GEORGETOWN-SCOTT COUNTY PLANNING COMMISSION

AGENDA

February 8, 2018

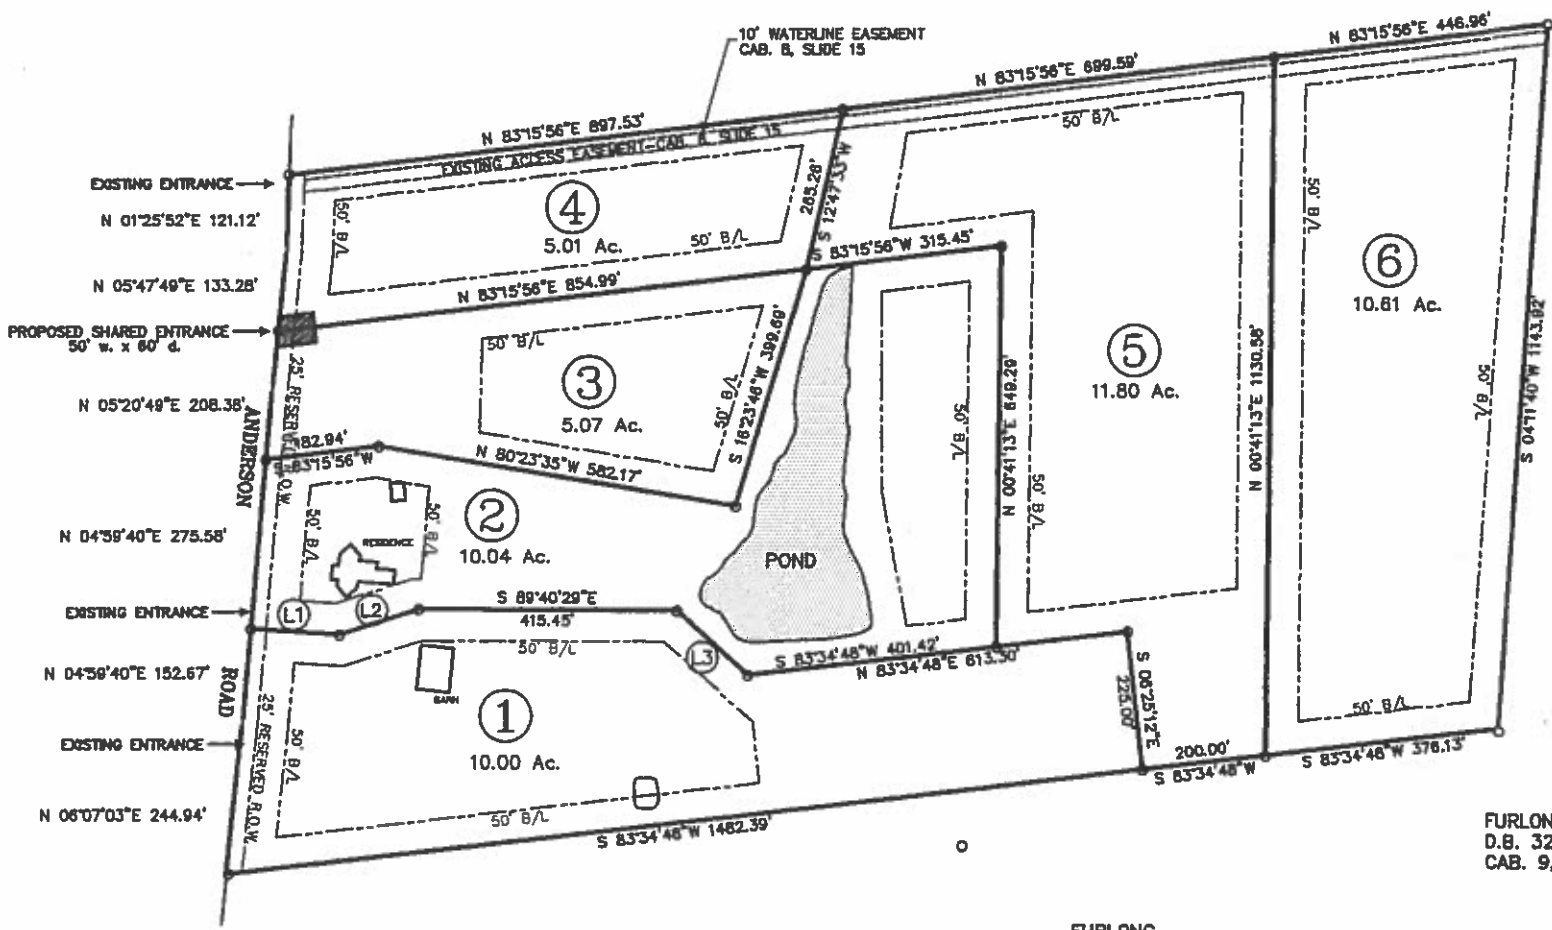
The proposed subdivision meets all planning requirements at this time. All tracts show the required 50-foot setbacks on all property lines and have at least 250 feet of width at the building line. The Health Department will need to conduct a site evaluation for the newly configured tracts to certify that an on-site septic system is feasible, but have not indicated any anticipated problems.

6. Prior to (as part of) the Final Subdivision Plat approval, the drainage easement on Tracts 1, 2, and 5 shall be shown.
7. Prior to (as part of) the Final Subdivision Plat approval, the Anderson cross road section shall be shown.

PRELIMINARY DEVELOPMENT PLAN
THE VILLAGES OF FALLS CREEK
 PHASE 1 - UNIT 4
 VILLAGE PARK DRIVE; GEORGETOWN (Scott County)

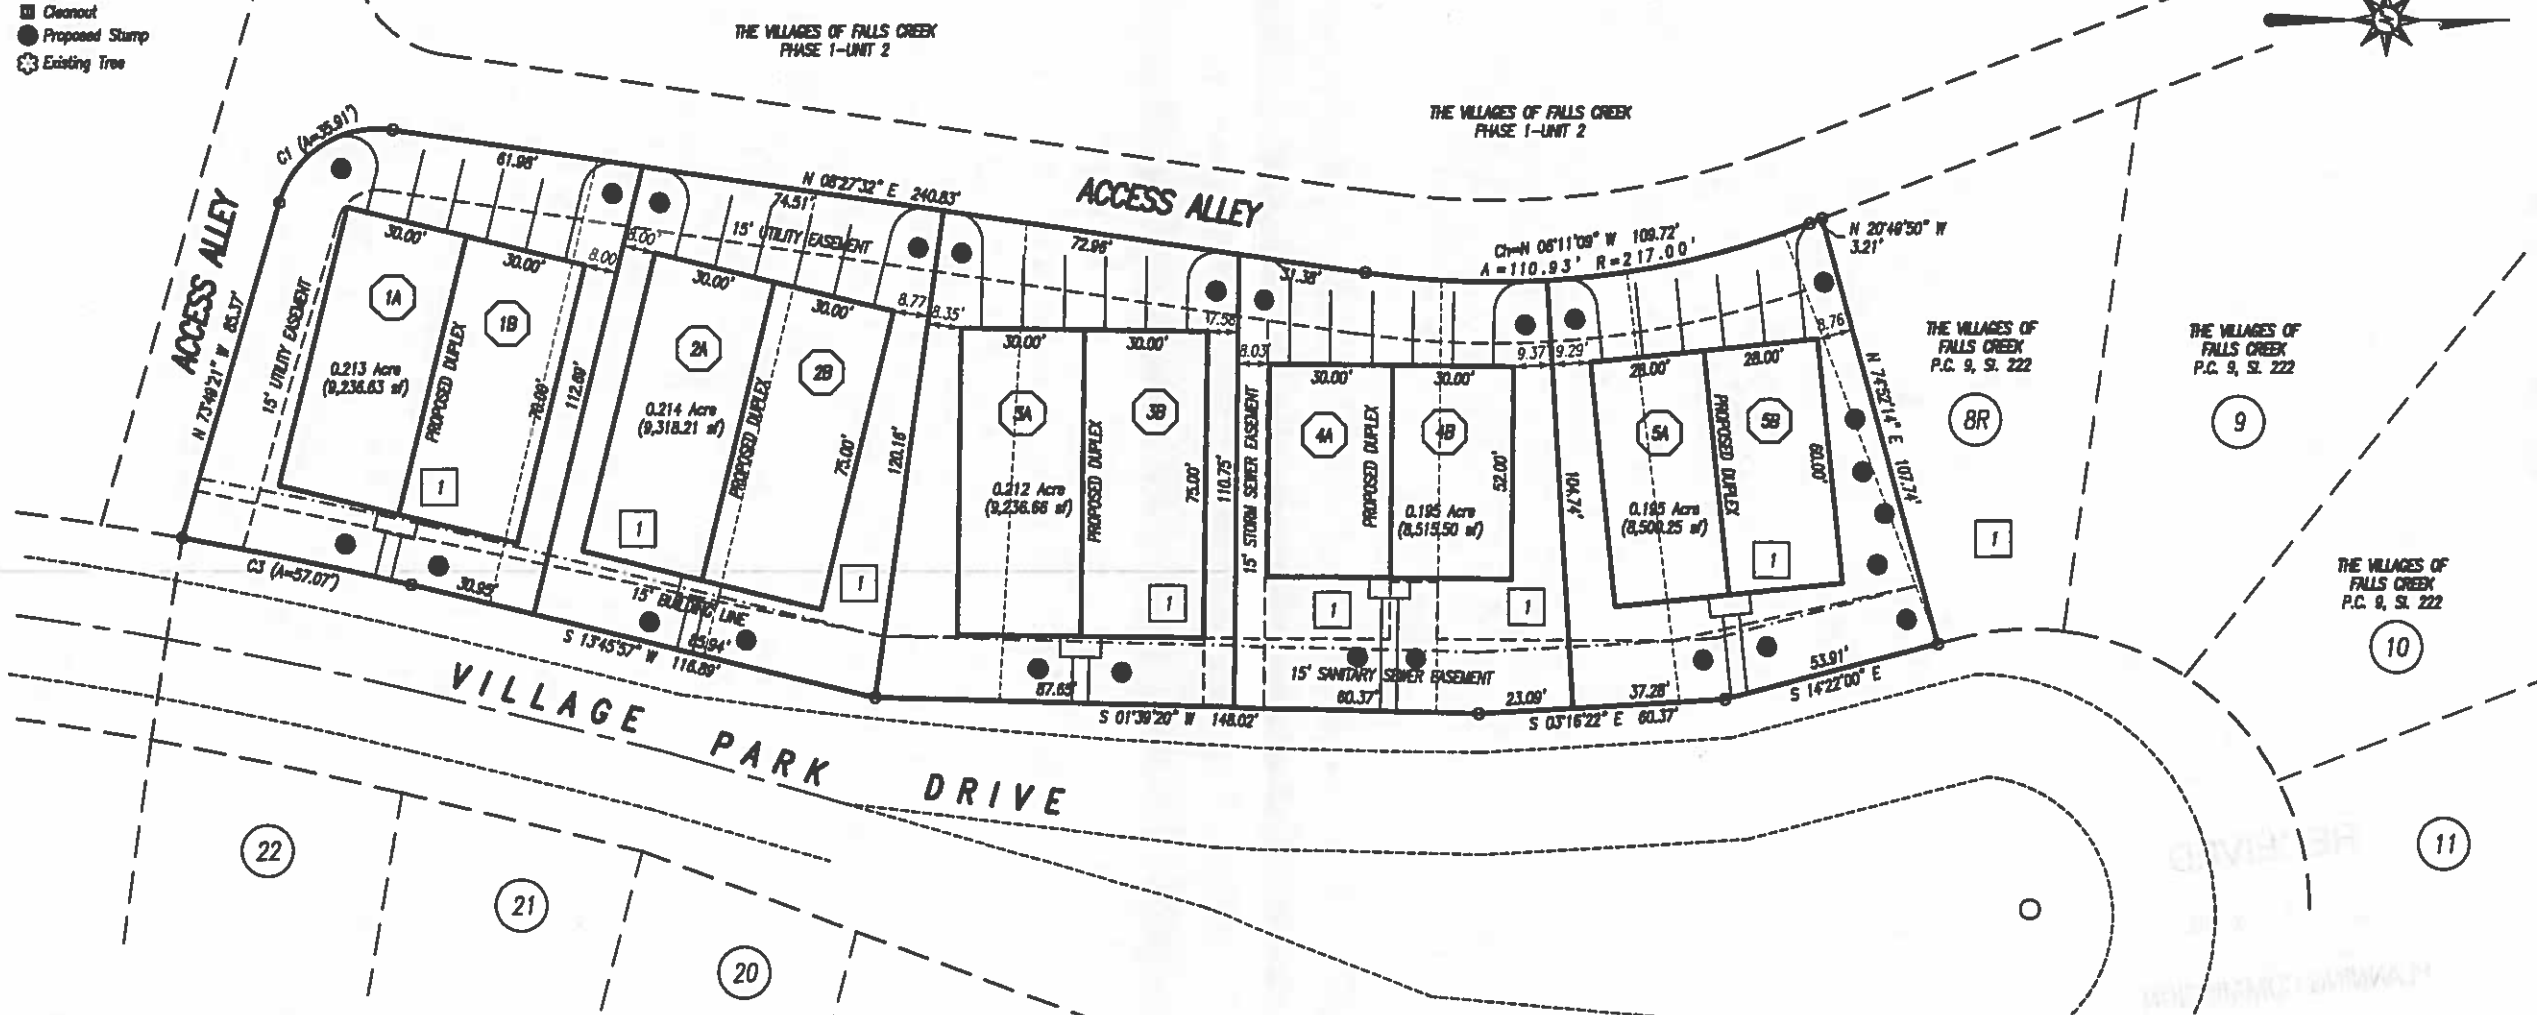
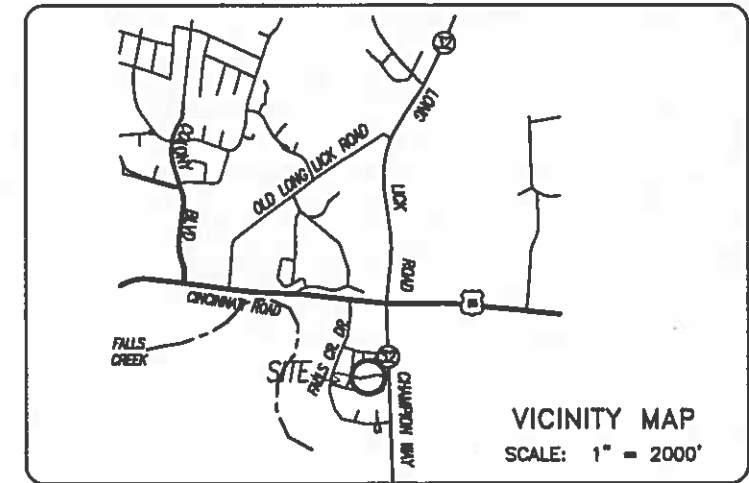
The setbacks are proposed to remain the same for the townhome development as what was approved for the single-family lots. 20-foot setbacks from Meadow Lane, 15-foot setbacks from Woods Point Circle, 15-foot setbacks from the access alley, and 7.5-foot setback from the single-family development to the south. If the Planning Commission approves this application, the side-yard setback will require a variance. The Schedule of Dimension Area Regulations requires a 25 feet setback for all multi-family structures such as townhomes and apartments. The Applicant is showing a side-yard setback of 7.5 feet, but at least 10 feet will be needed to include an appropriate landscaping buffer.

Parking for the townhome development is proposed through parking areas and garages accessed by the access alley. The Development Plan is showing an appropriate amount of parking, but staff has some concerns about how the parking areas will be constructed. There are several easements along the rear of these lots, and the plan calls for much of this area to be paved, which may limit access to these easements. Several of the parking lot peninsulas are also proposed to extend into the right-of-way of the access alley.

The duplexes are proposed to be served by surface parking only (no garages). These parking areas will substantially increase the paved area over platted utility easements. The preliminary plat does show an appropriate amount of parking for the proposed duplex units.

The plan shows an appropriate amount of interior VUA landscaping to meet the requirements. Section 6.13 of the *Landscaping and Land Use Buffers Ordinance* requires a landscaping buffer 5 feet wide to screen the vehicular use area from the adjoining property to the south. This buffer area can be met by the shown interior landscaped area, but the Final Development Plan will need to show the required hedge, fence, wall or earth mound.

Section 6.12 of the *Landscaping and Land Use Buffers Ordinance* requires a 10-foot landscaping buffer between all multi-family zones and single-family zones. This buffer should be populated by 1 tree per 40 feet plus a continuous 6-foot tall planting, hedge, fence, wall or earth mound. This buffer area is typically required between different zoning districts, but should be applied if the Planning Commission approves this development plan, because the Applicant is proposing a substantial increase in the density in such close proximity to existing single-family residential.

1. The Applicant will need a recorded minor plat consolidating the single-family lots from the townhome area prior to Final Development Plan approval.
2. The sidewalk along the front of the townhome development shall either be reconstructed in the right-of-way or an access easement shall be placed around it to allow for public usage.

3. A 10-foot wide landscaping buffer shall be installed between the townhome units and the adjoining single-family residences to the south.
4. Landscaping along Champion Way shall be installed as part of the Final Development Plan for the townhome development.

5. The parking area peninsulas for the townhome development shall not extend into the right-of-way for the access alley.
6. The Applicant will need to provide a stormwater management summary to evaluate and account for increase in impervious area.

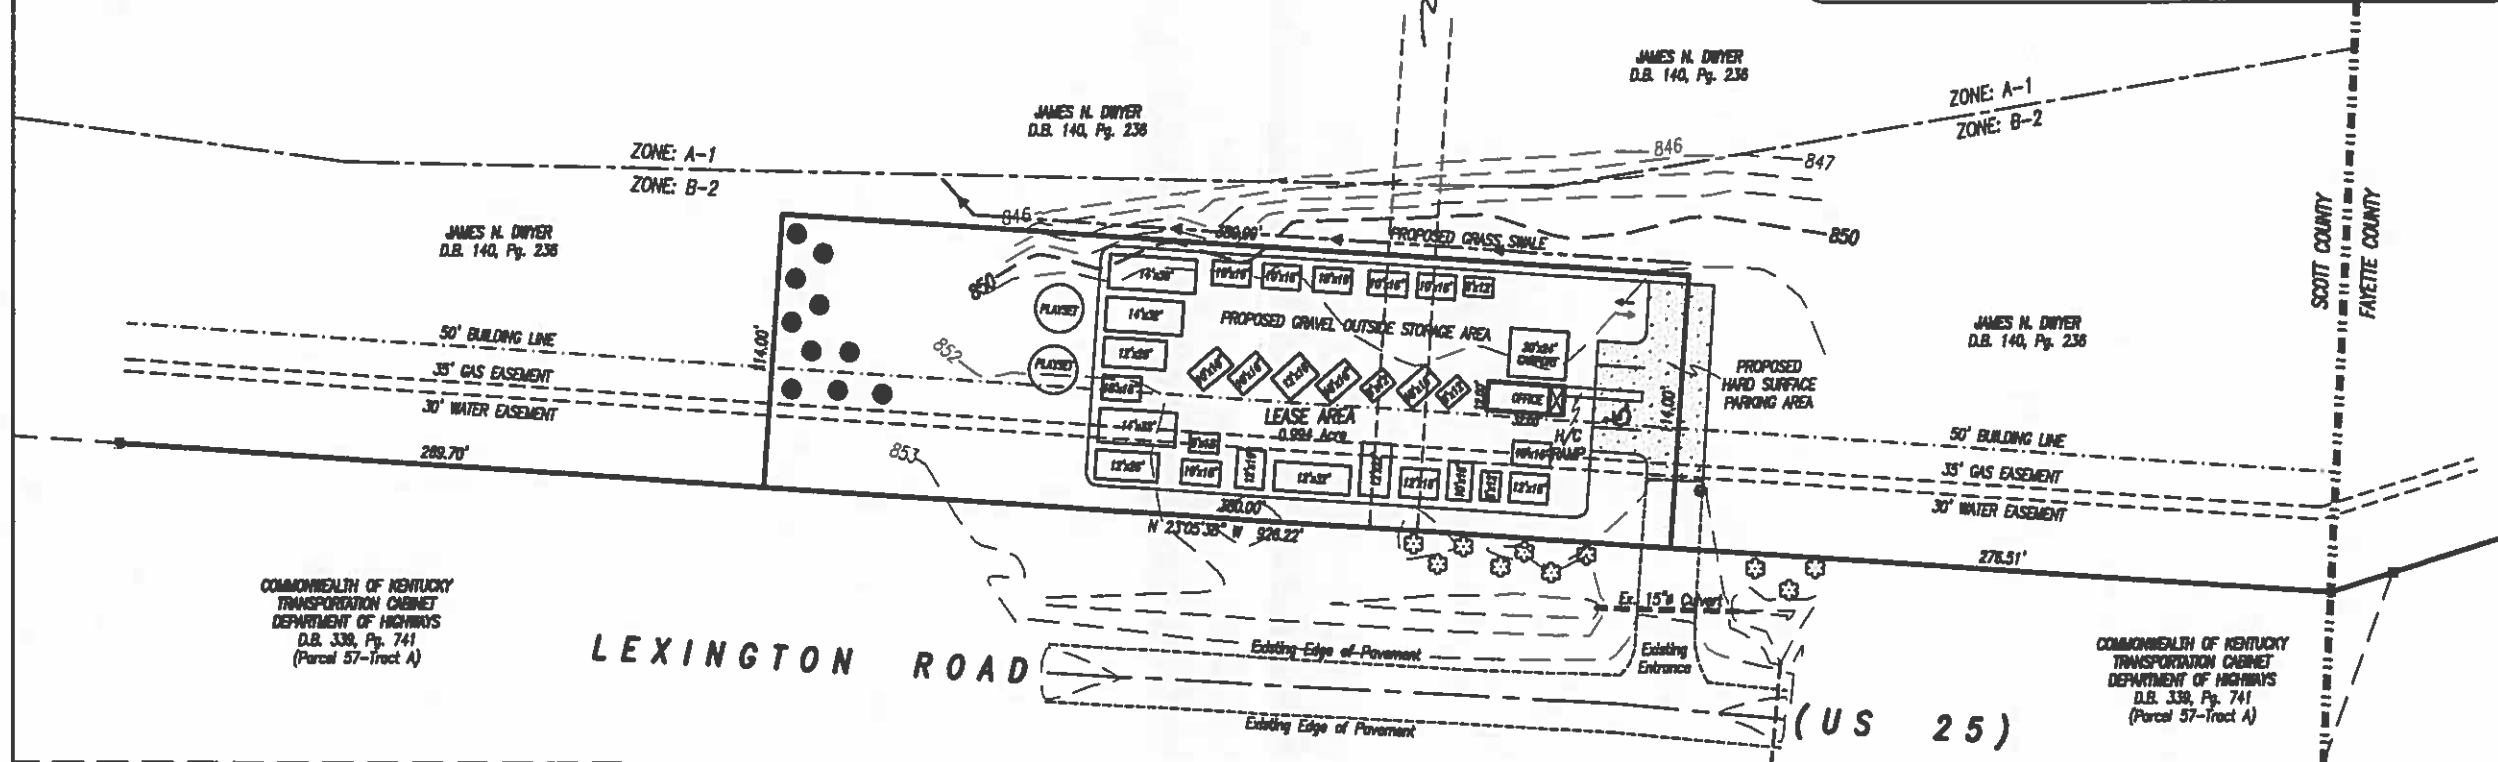
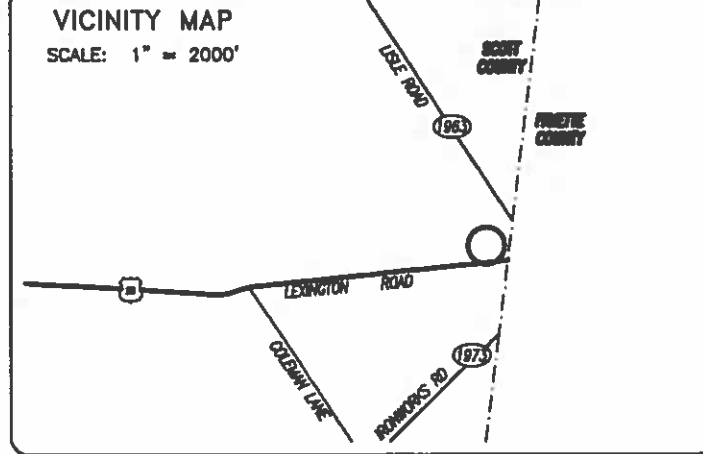
Gravel Area: The Applicant has proposed to store the portable buildings outdoors on a gravel area. Outdoor Storage and Processing in a B-2 zone requires a Conditional Use Permit. The Applicant will go before the Board of Adjustment on February 1st to seek approval to display and store the portable buildings outdoors. Any use of gravel requires Planning Commission approval.

For the 0.994-acre site, a total canopy coverage of 10,392 square feet is required (0% preserved canopy, 24% new canopy). The Applicant has proposed 4,000-square feet (9.2% coverage) of new canopy. The Applicant does not meet this requirement with the current proposal, and has asked for a variance to reduce the canopy coverage requirement from 10,392-square feet to 4,000-square feet. Staff is in support of the variance request due to the temporary nature of the business and the fact that the Applicant is not required to plant trees for screening or for interior landscaping.

1. Variance to reduce the minimum canopy requirements (Min Required: 10,392 SF, Proposed: 4,000 SF)
2. Variance to allow for the use of gravel in the storage areas.
